ADDENDUM

Project: **Crestwood School District
Crestwood High School
Field Building & Site Improvements**

Date: **March 29, 2023**

Addendum Number: **#3**

A13 Building A: Area 1 Exterior Wall Section
Scale: 1"=1'-0"

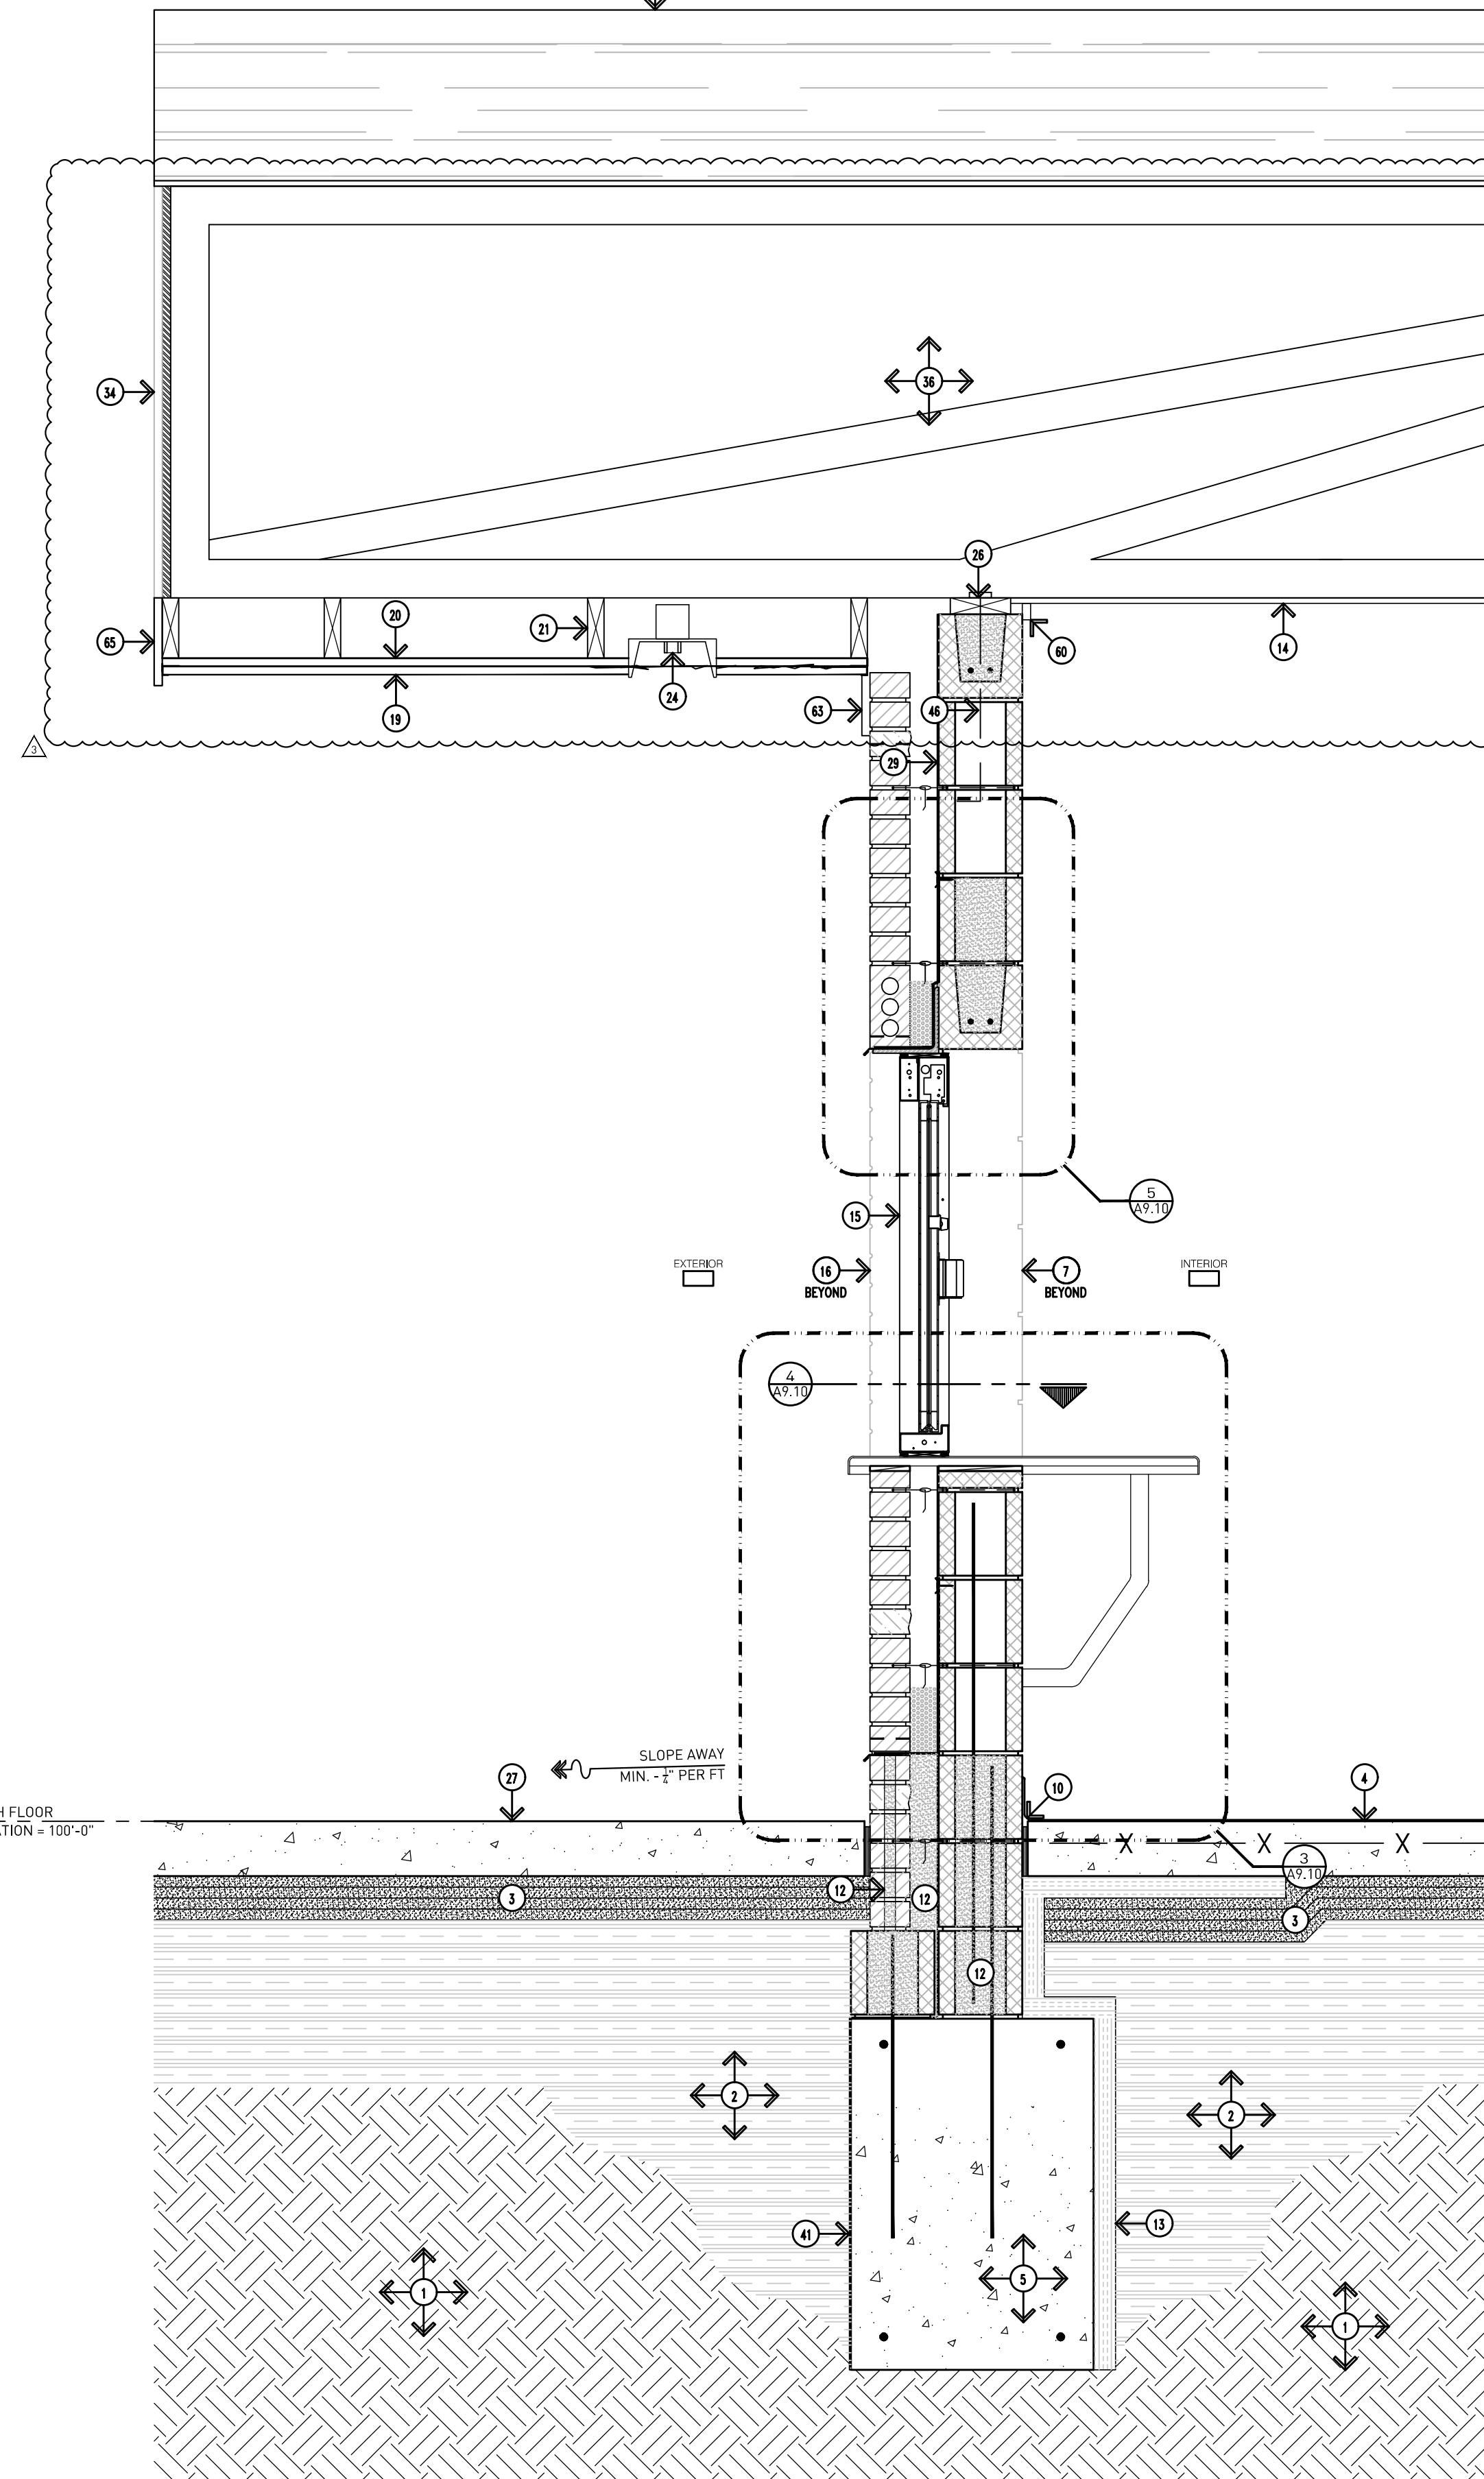
REVISE: Detail A13/A9.01 as indicated on sheet.

B1
A9.02 Building B: Exterior Wall Section
Scale: 1"=1'-0"

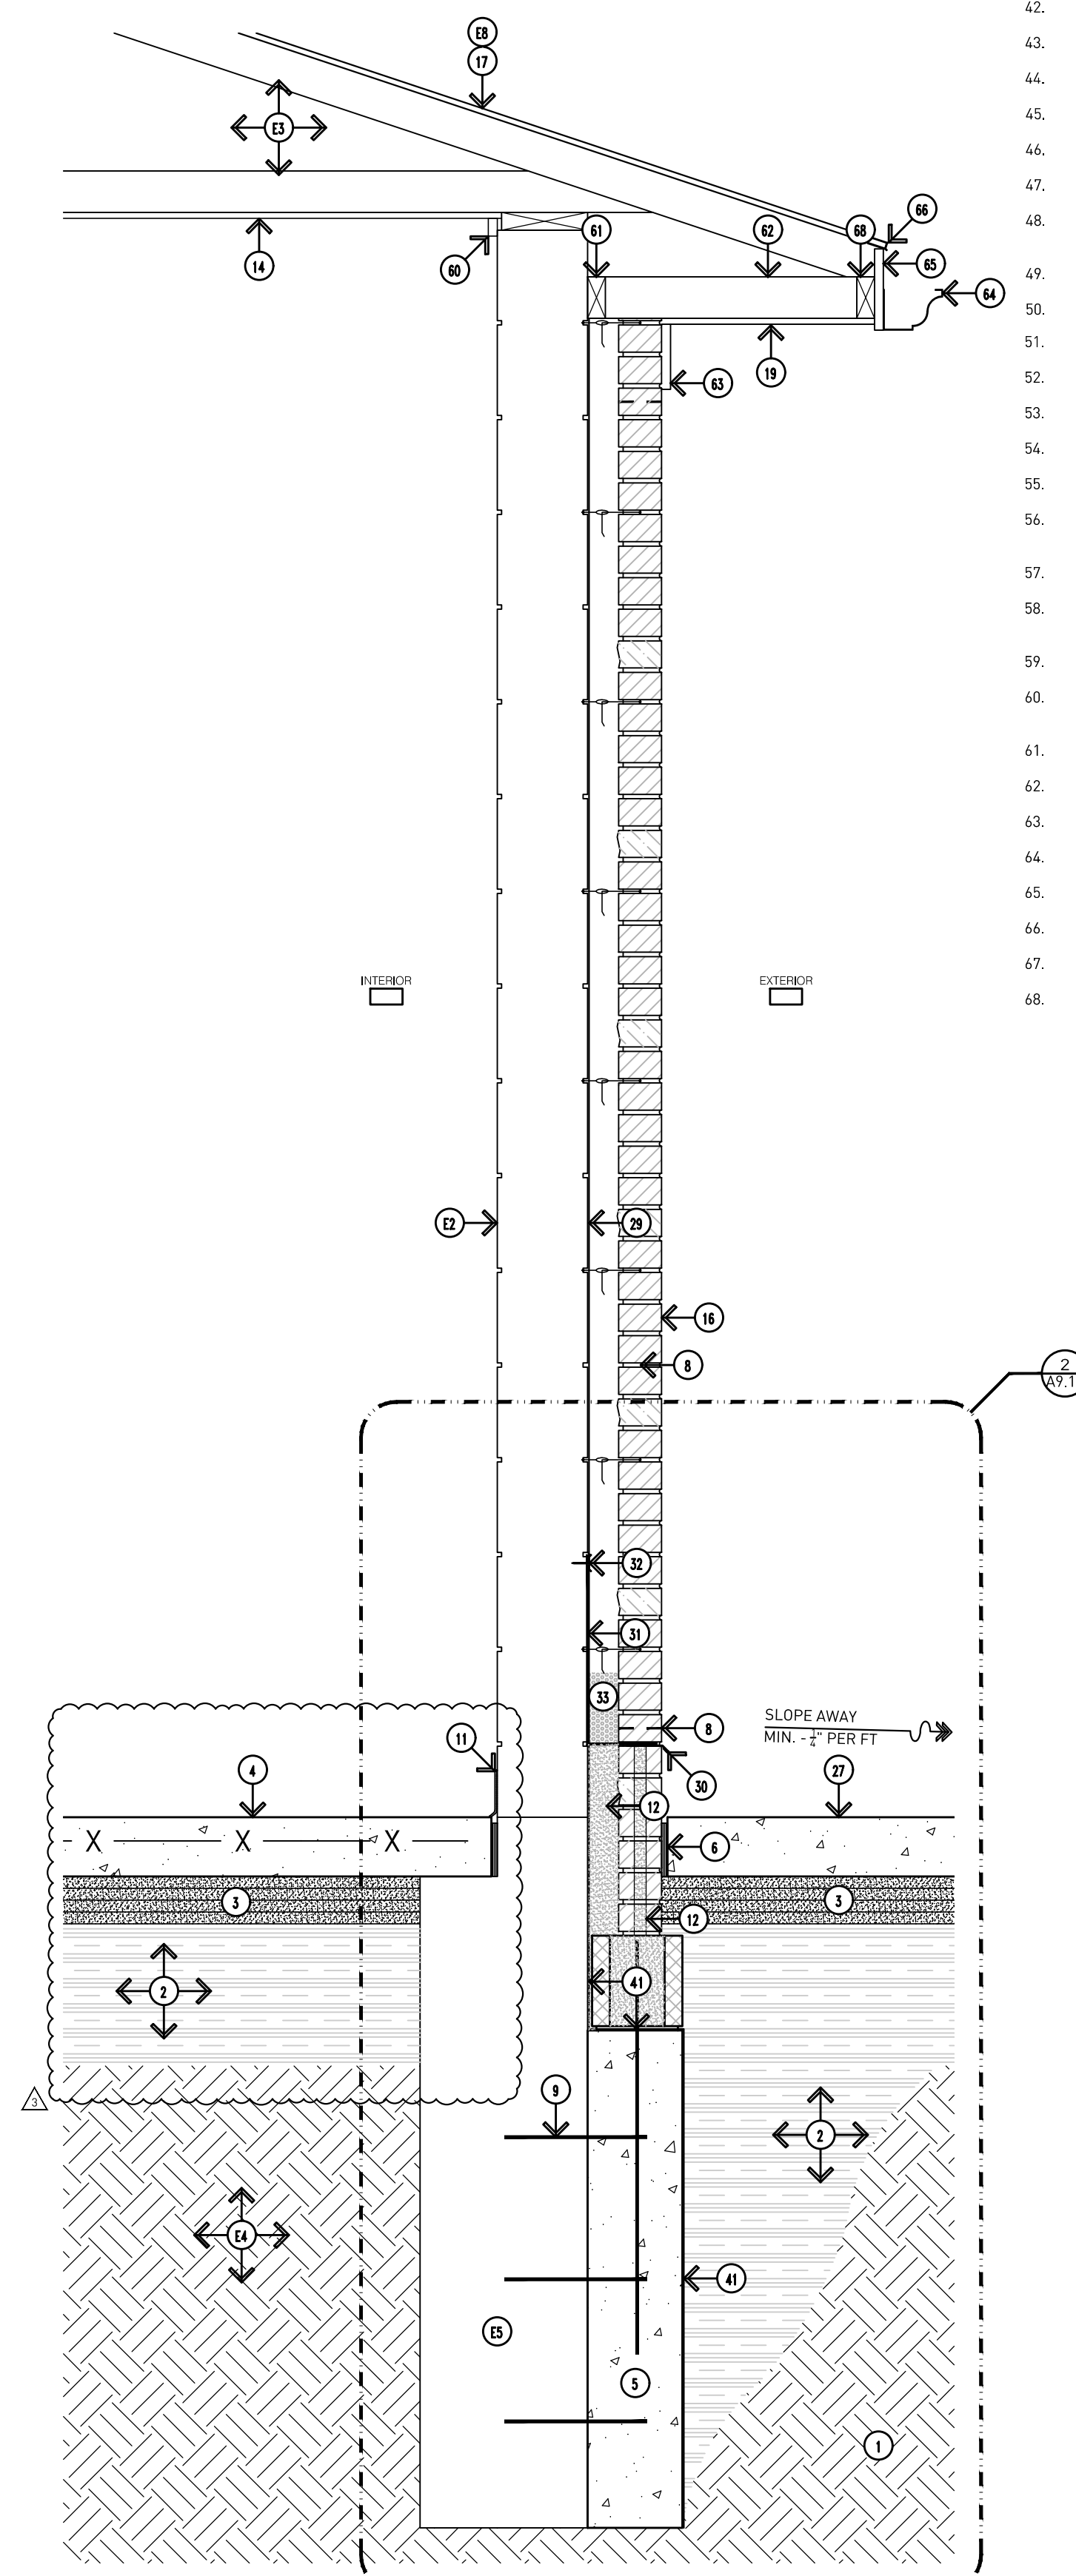
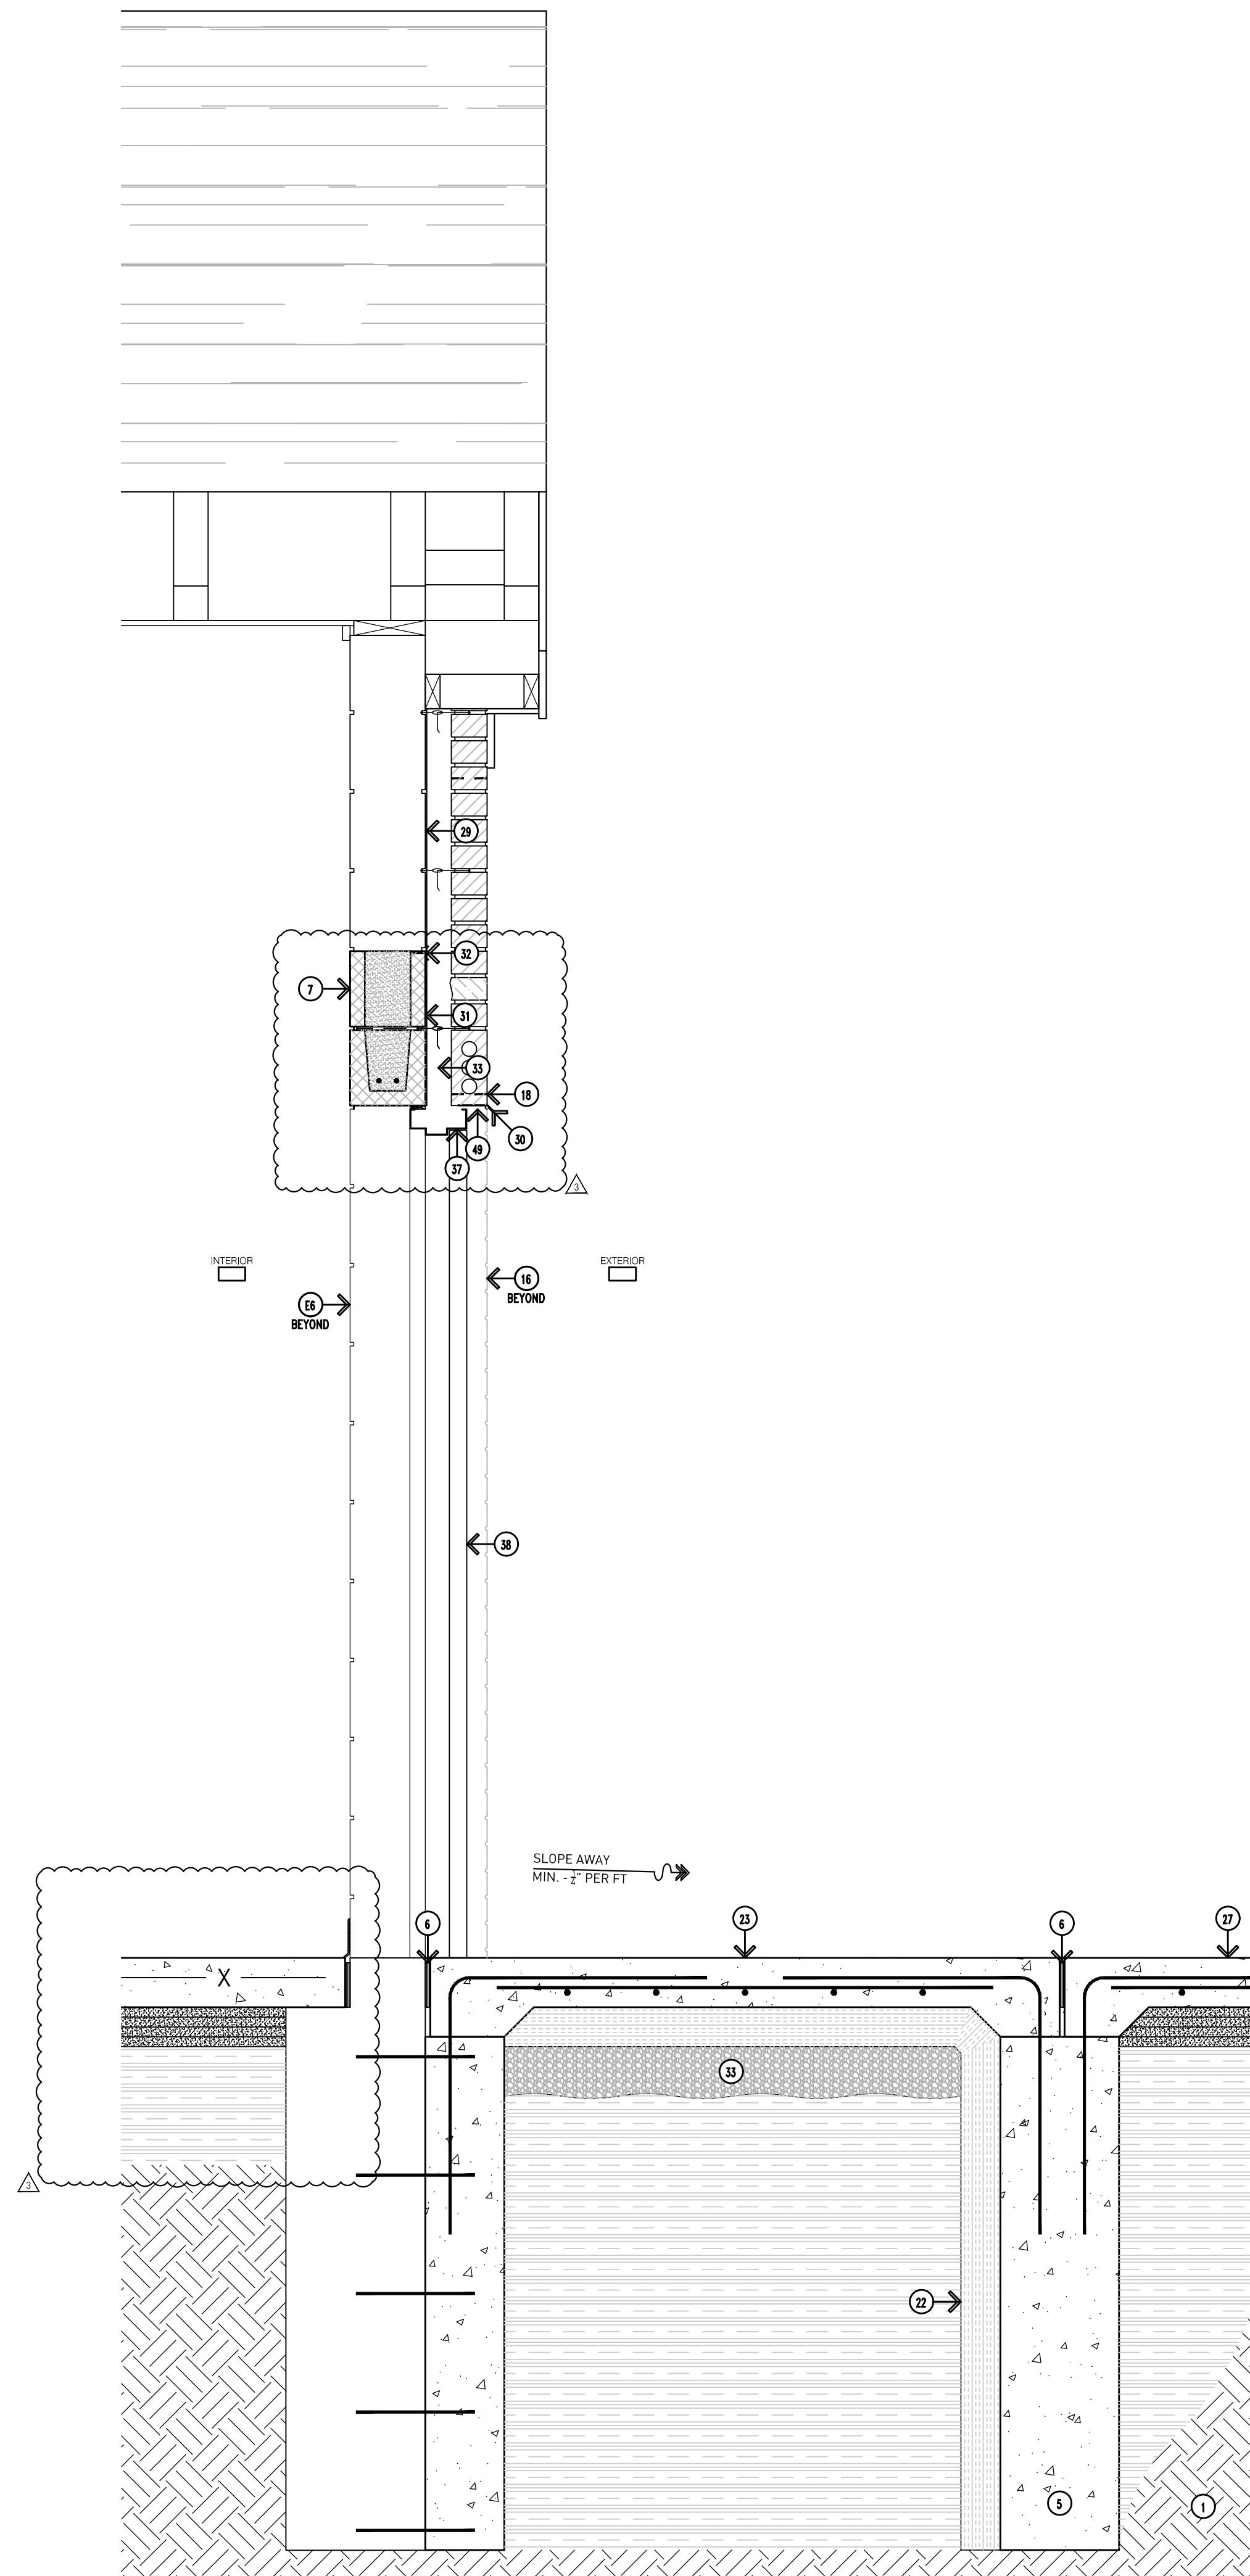
CHANGE: Note Tag E1 to 4 on B1/A9.02.

REVISE: Detail B1/A9.02 as indicated on sheet.

REVISE: Detail B2/A9.02 as indicated on sheet.

REMOVE: Note Tag 35 from Detail B1/A9.02.
